FINAL
ENVIRONMENTAL IMPACT STATEMENT

**F-15E BEDDOWN AT SEYMOUR JOHNSON AFB,
NORTH CAROLINA**

November 18, 1988

- (a) Responsible Agency: United States Air Force
- (b) Proposed Action: Conversion of F-4 to F-15E aircraft that will be equipped with the new Low Altitude Navigation and Targeting Infrared for Night (LANTIRN) system at Seymour Johnson AFB, Wayne County, North Carolina.

FIGURE 4.2-1
PROPOSED ACTION
NOISE MAP-BASE

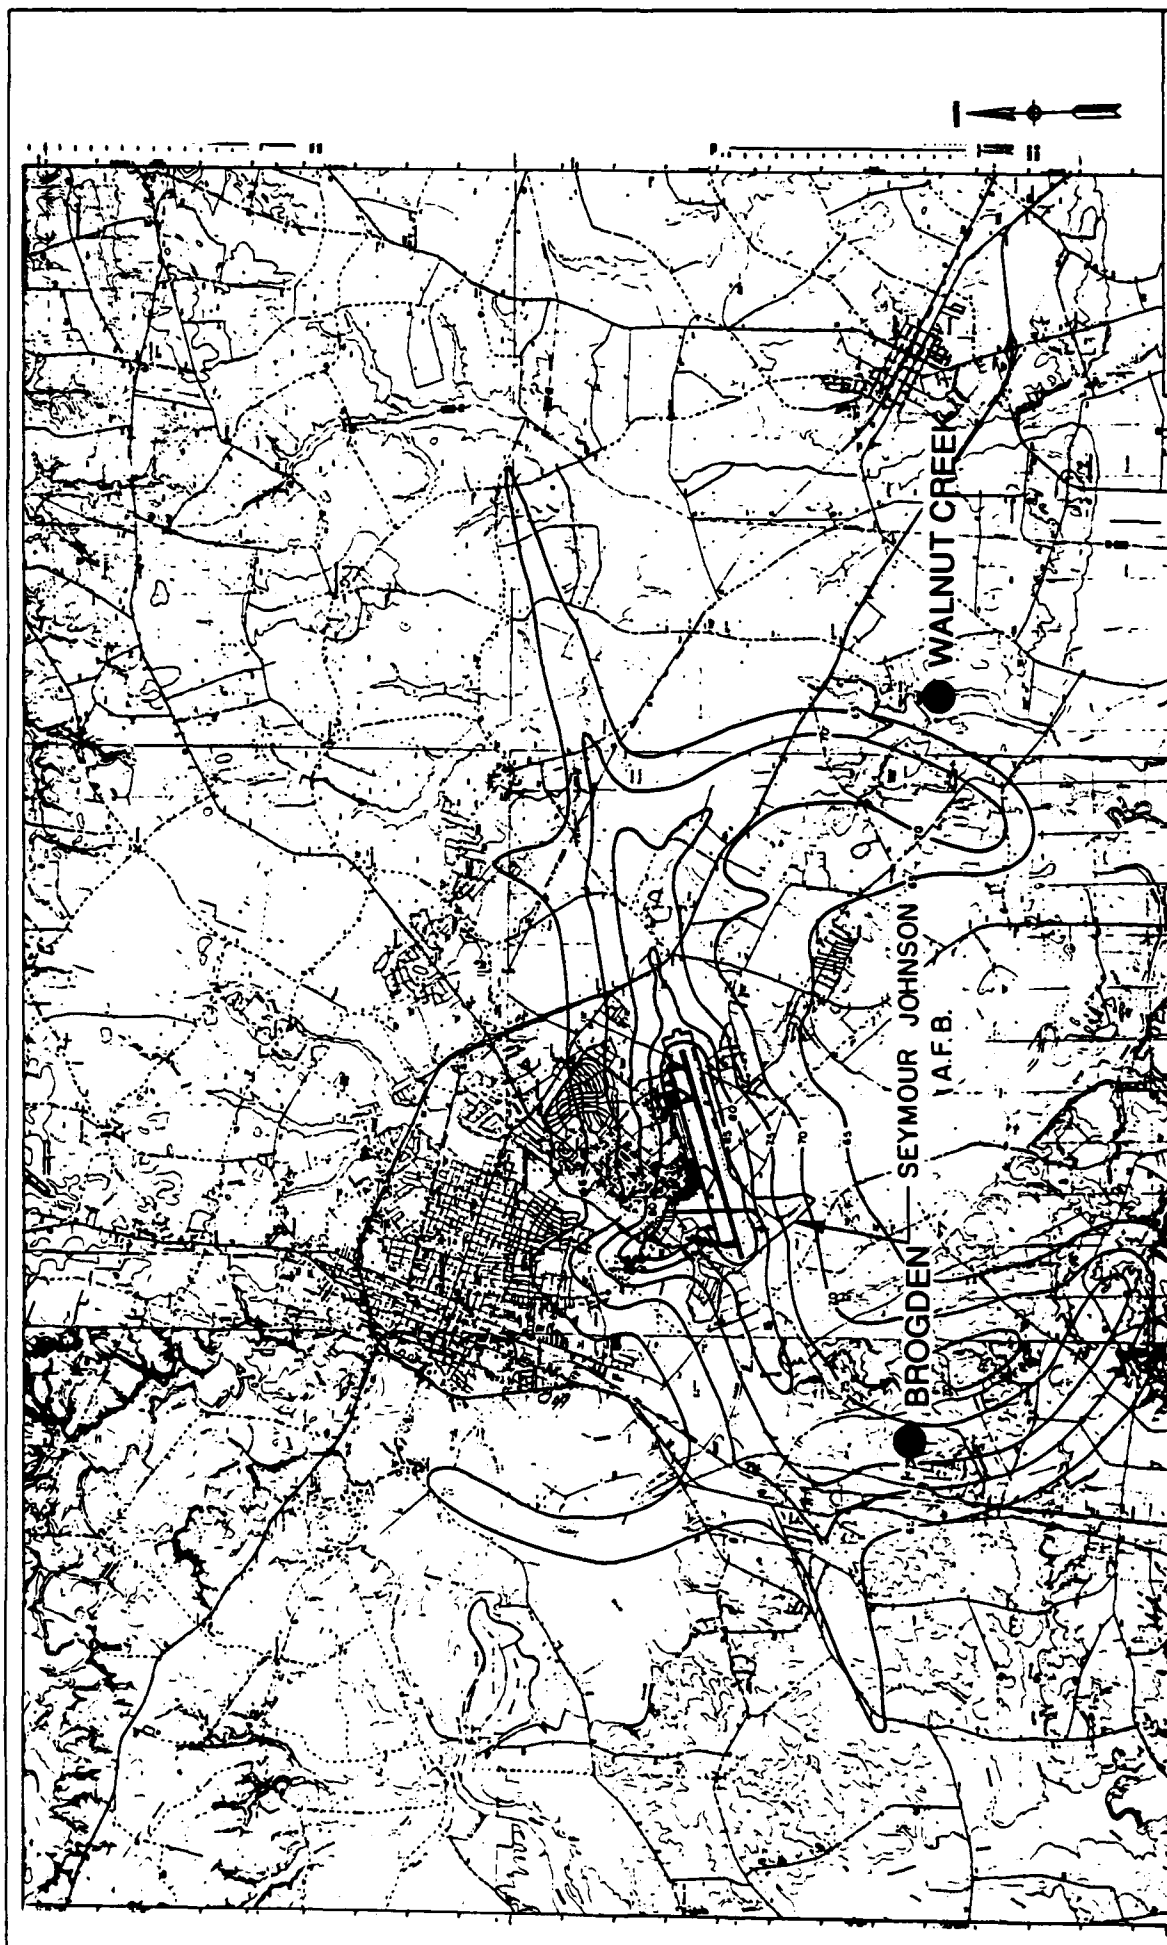
7. In line with comment 4, Figure 3.2-2 only provides a benchmark for showing the noise contours during the 1983 time period. To gauge the short term impacts, the reader should compare Figures 3.2-3 and 4.2-1 which are comparably scaled. Brogden and Walnut Creek have been identified on the maps which are provided in the errata section of this document. Tables 4.7-3 and 4.7-4 both represent "worst case"; the change in the noise level column represents the difference between a value of 55 DNL or the comparable compatible use district (CUD) from Figure 3.2-3. (if the area in question is within the AIC/JZ), respectively.

18. p. 3.4-12, 3rd paragraph, last line: Change Figure 3.0-1 to 3.0-2.
19. p. 4.2-2, Figure 4.2-1: See revised Figure in this section.
20. p. 4.2-4, 2nd paragraph, 3rd line: Change 38 to 14.

MILITARY TRAINING ROUTE MAPS

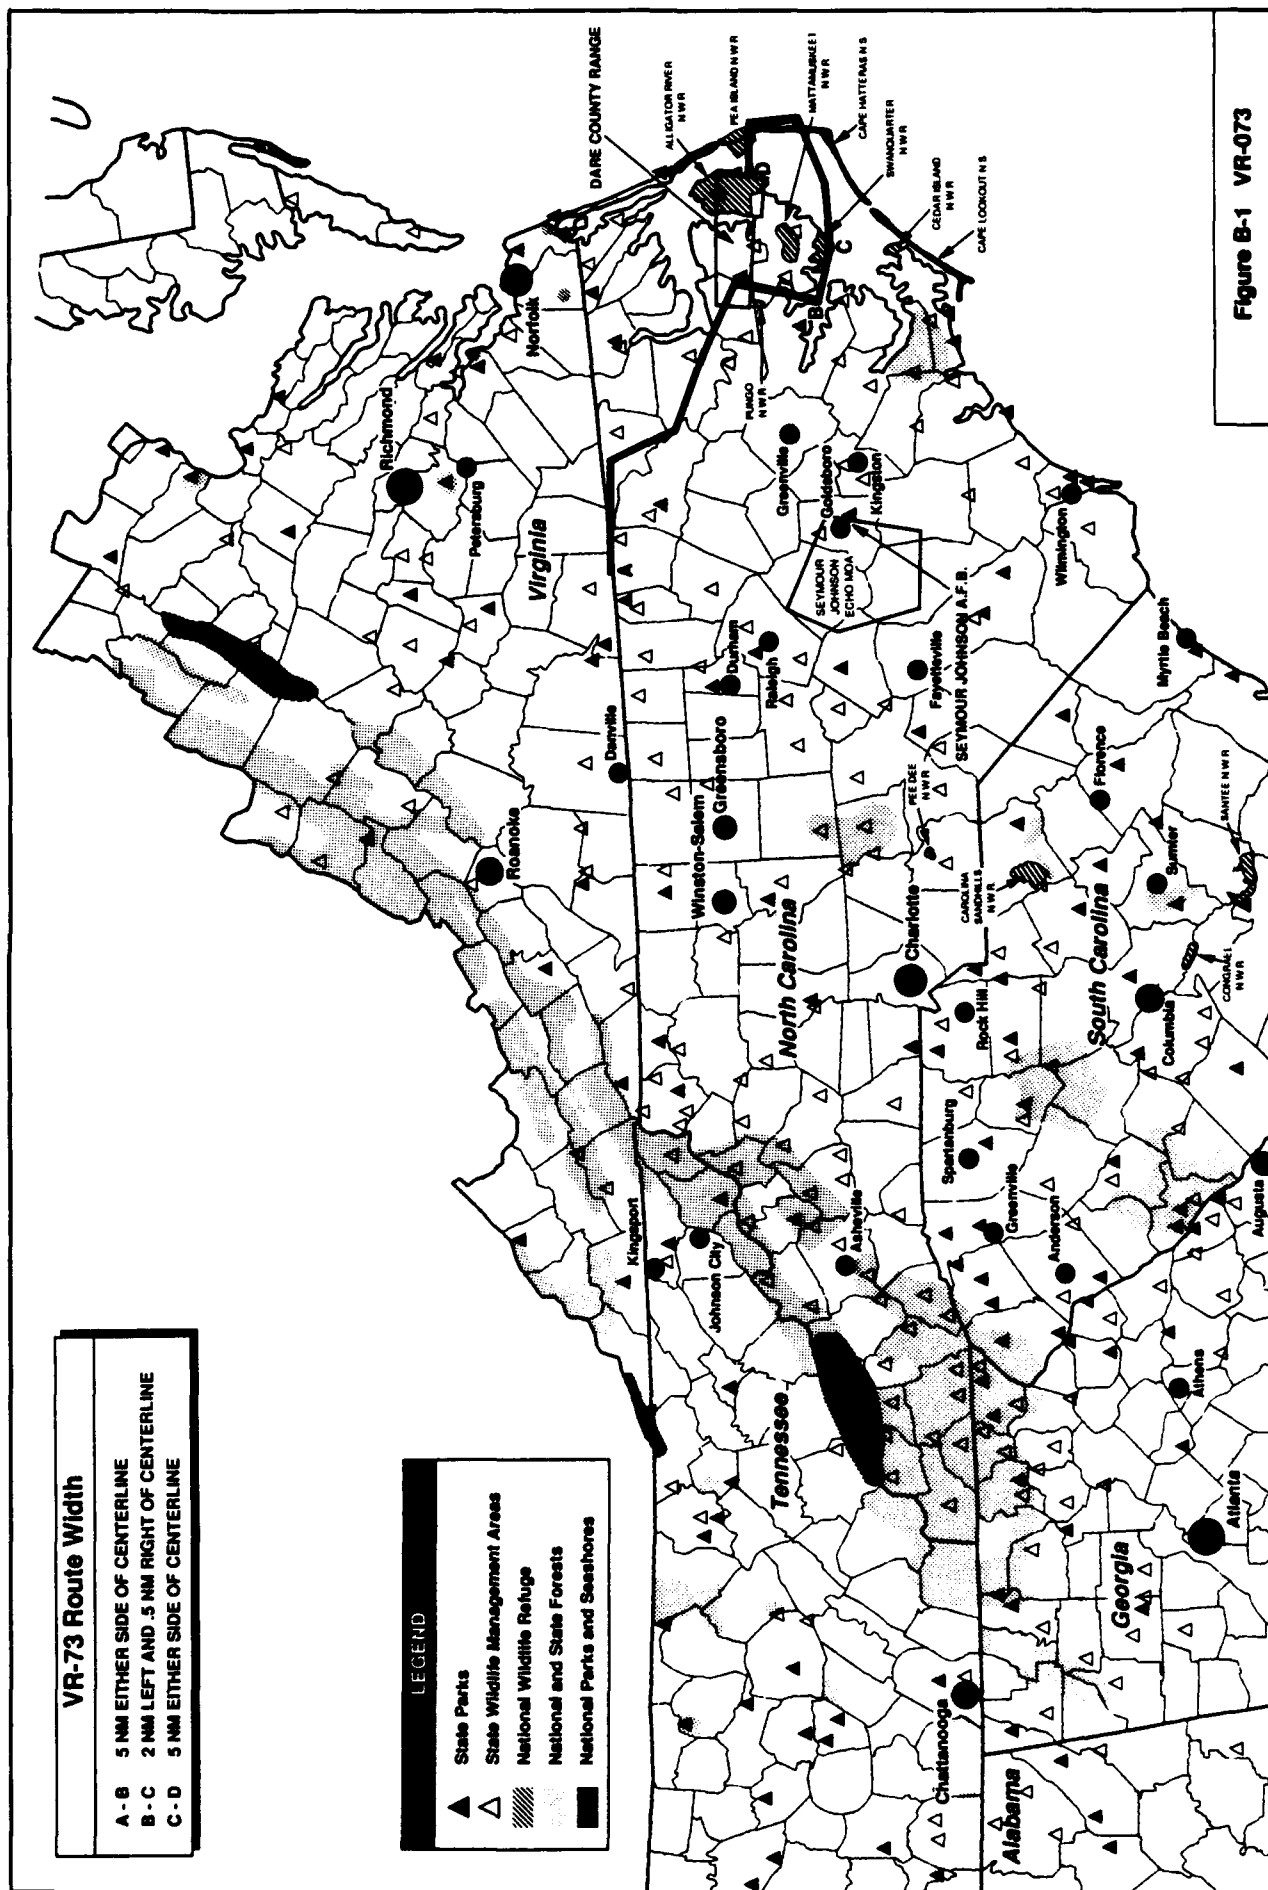
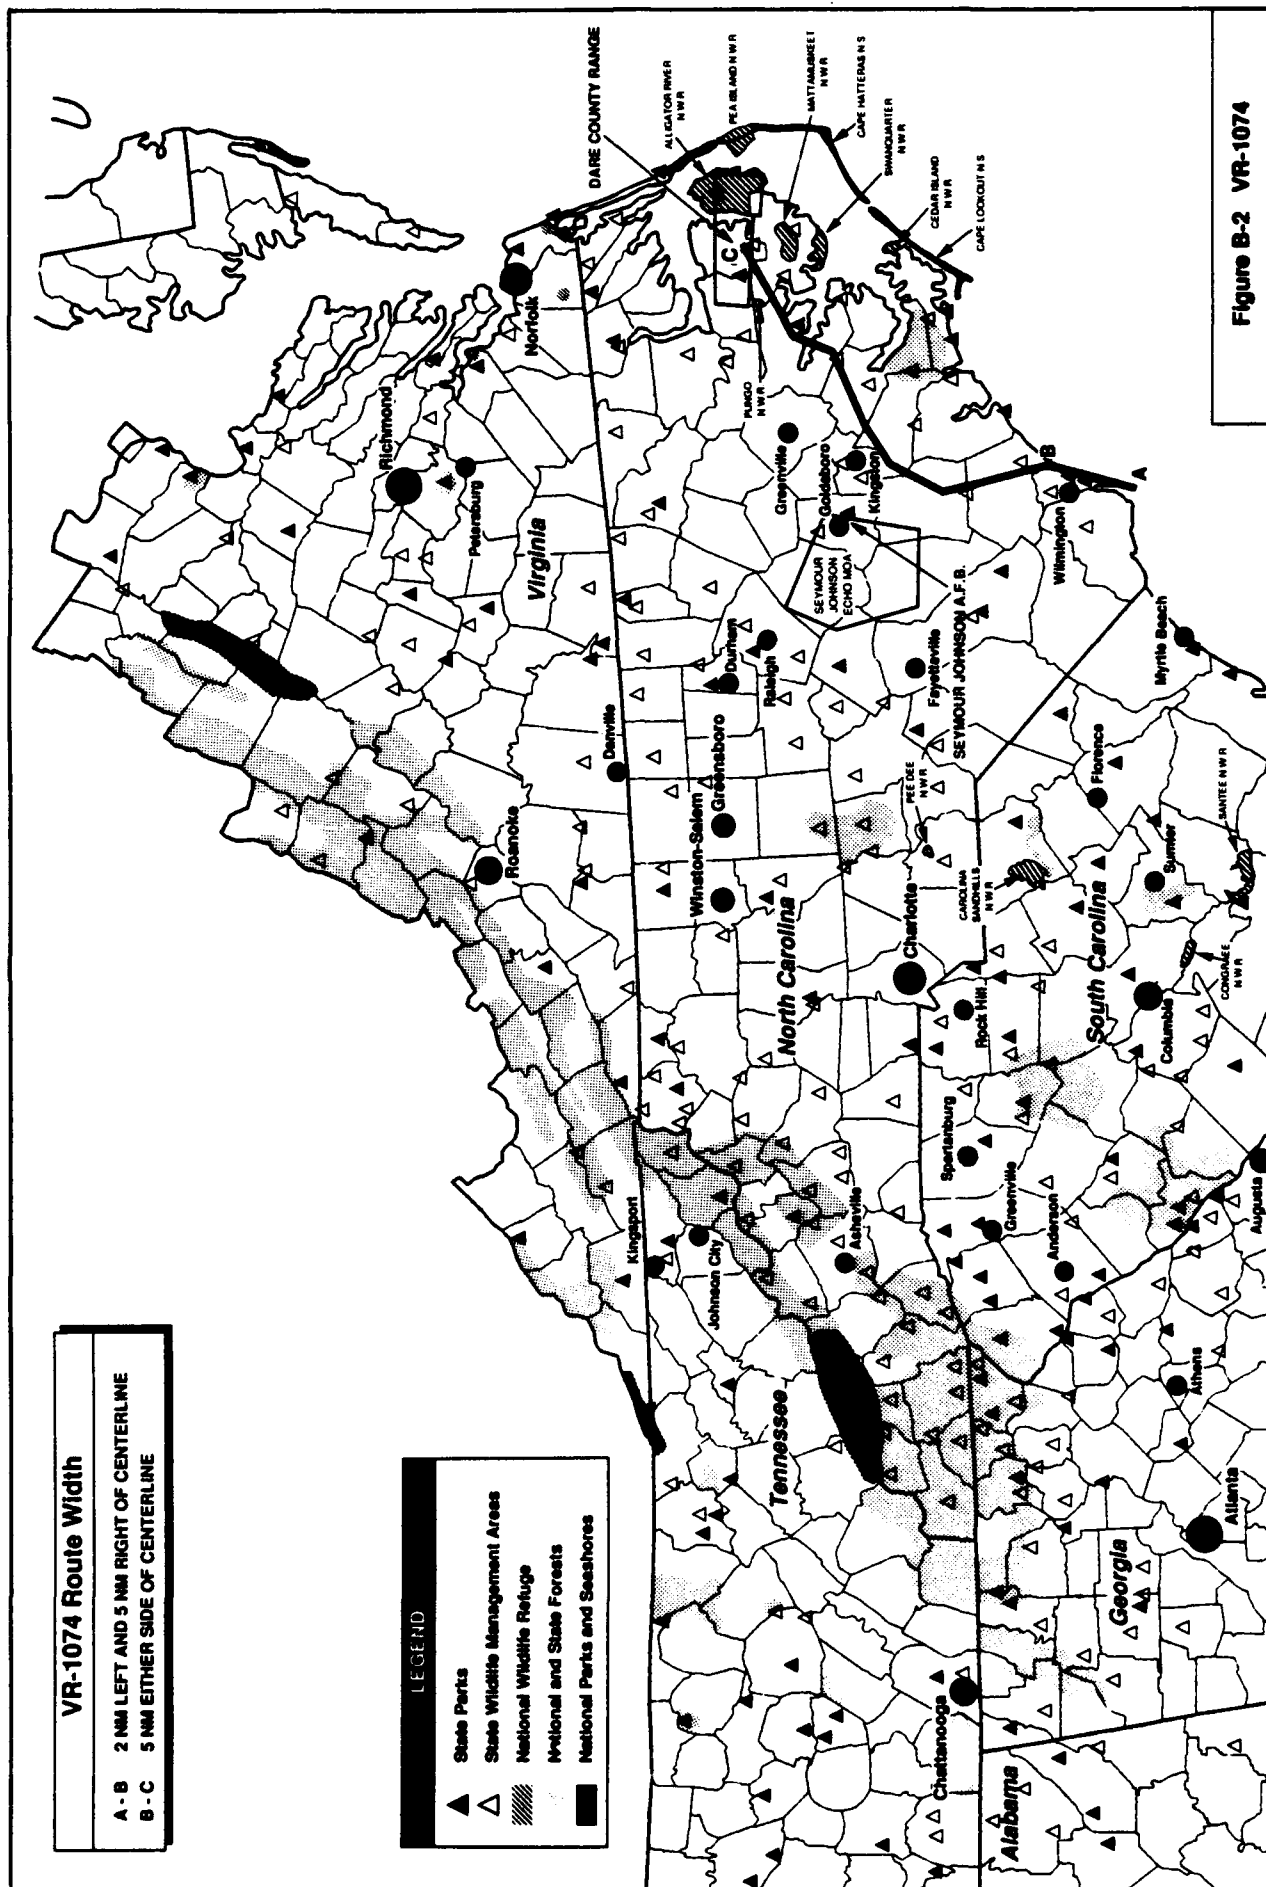
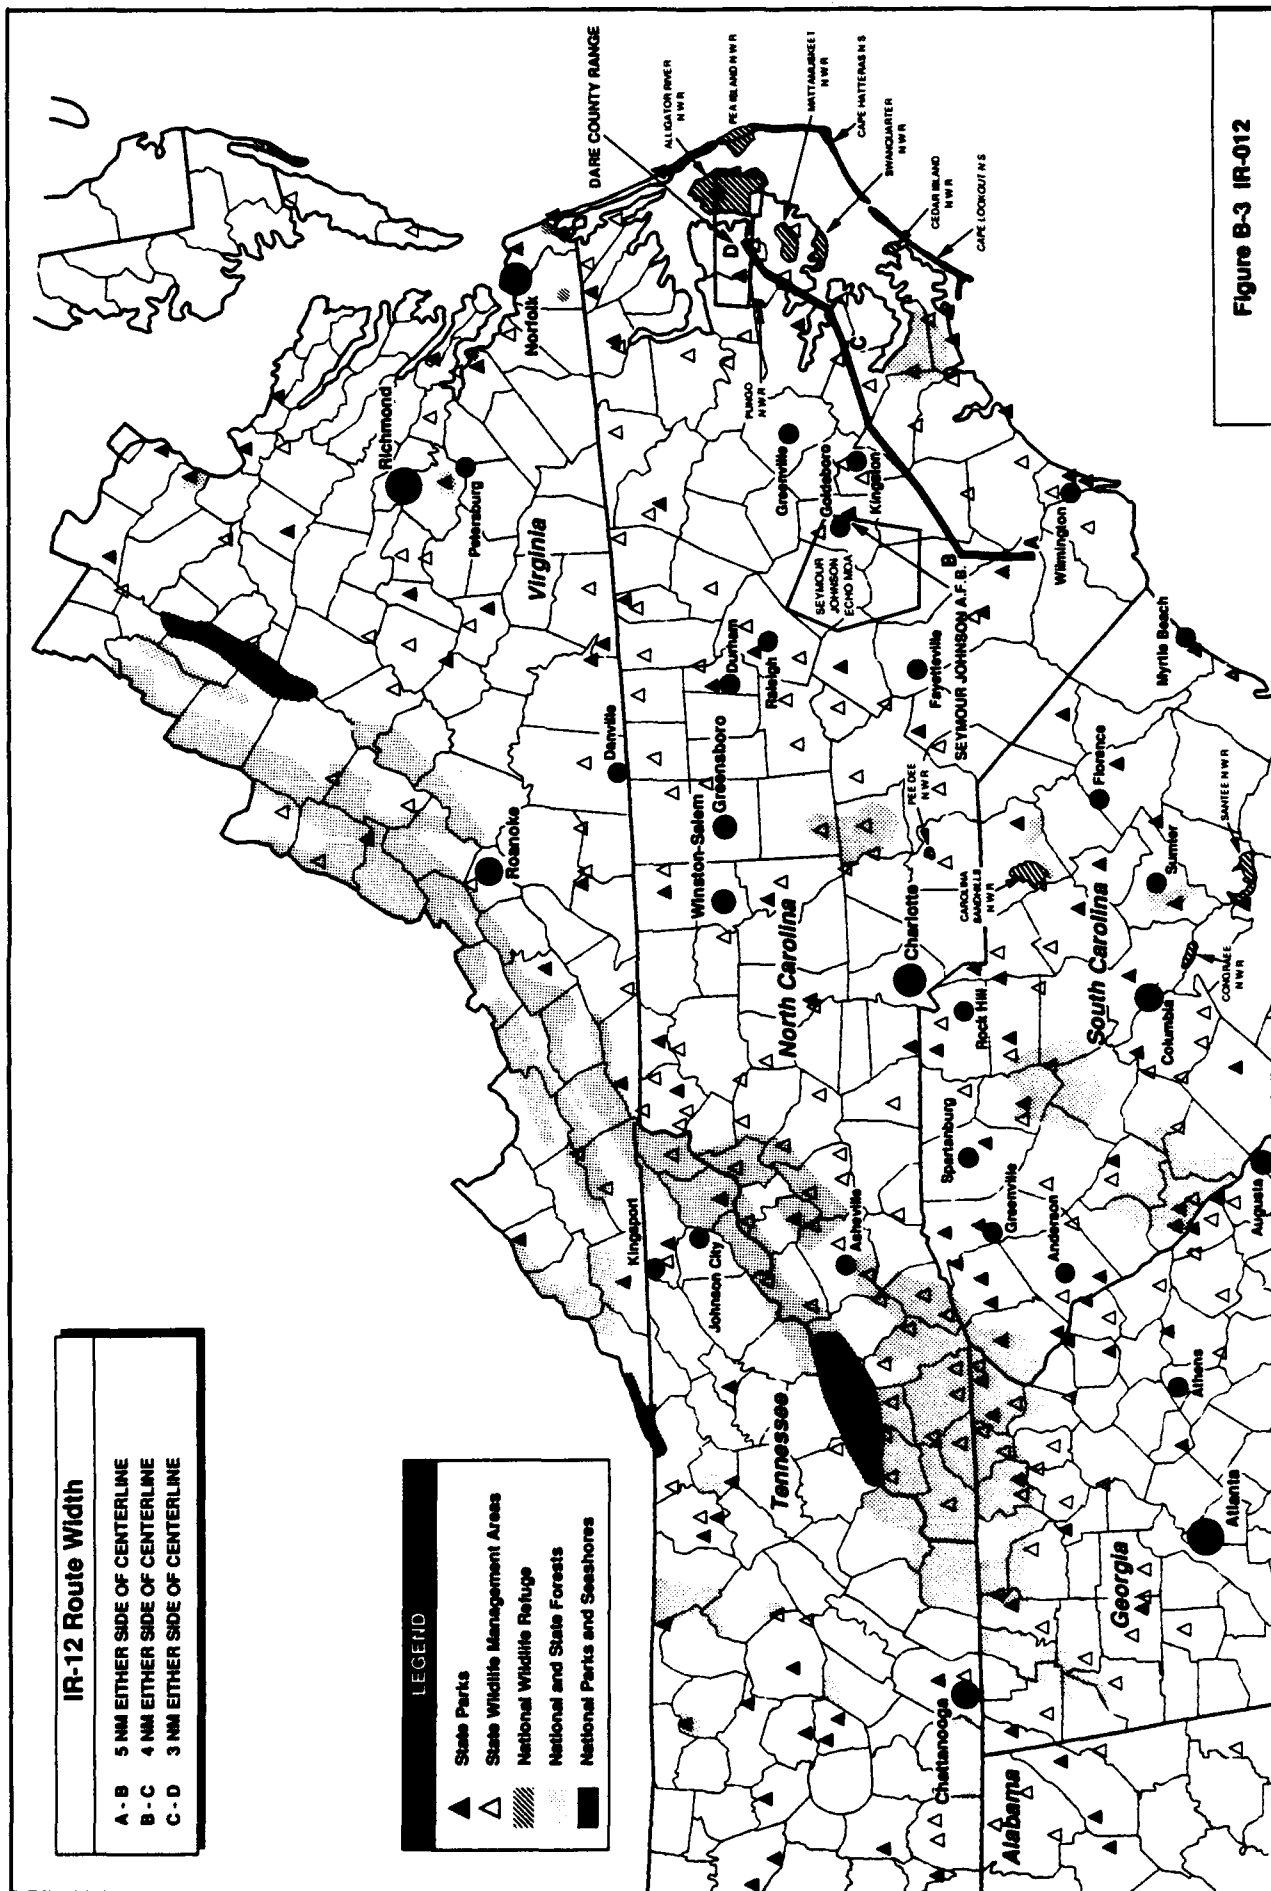
Page 3.0-3. Figure 3.0-2 only qualifies as a general representation of the MTR proposed for use and is not sufficient

to show their relationship with other facilities. For instance, neither R-5301 and 5302 nor R-5313, or Pamlico MOA are on the map. It is impossible to identify the location of any site in the interior of the state if it is not on the map.

77. The correct reference is to Figure 3.0-2. See errata (Chapter 5). Additional information on the location of "wildlife management and recreation areas" is provided in Appendix B.

13. p. 2.4-2, Table 2.4-1, Impact Area, No Action Alternative, and Proposed Action columns: Insert "Fire Potential", 0, and 0, respectively.
14. p. 3.0-3, Figure 3.0-2, VR-096 and VR-1043. Routes were drawn beyond legs specified in AP1B extracts for MTRs. See revised maps in Appendix B.
